Product Discontinuation Notices

No. 2009274E

Discontinuation Notice of Strobe Controller. 3Z4S-LT MLEK-C100E1TS

Dimensions/ Mounting dimensions

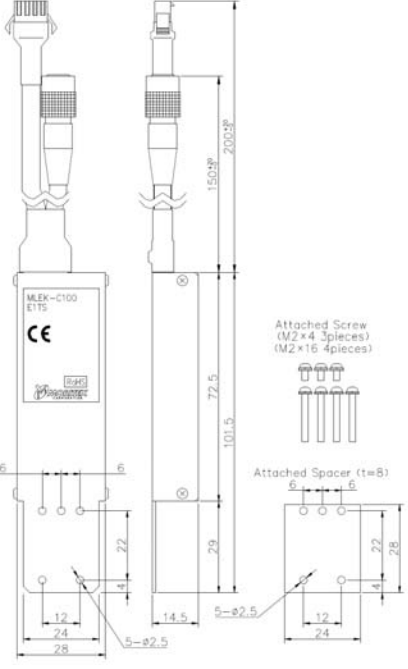
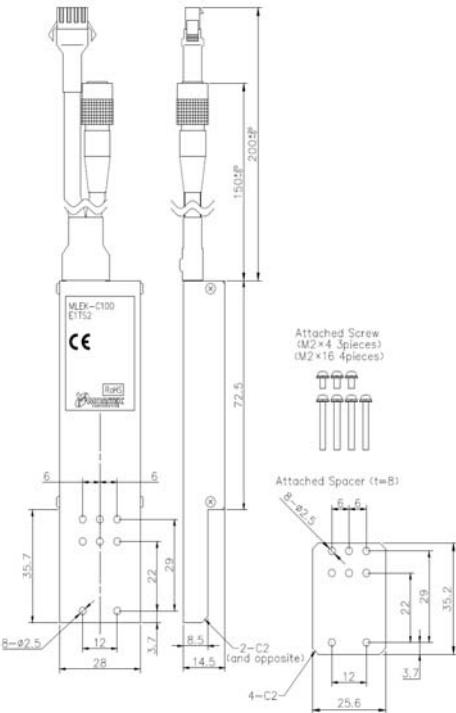
Model	Body Color	Dimensions	Wire connection	Mounting Dimensions	Characteristics	Operation ratings	Operation methods
3Z4S-LT MLEK-C100E1TS2	**	*	**	*	*	**	**

* : The change is a little/Almost compatible
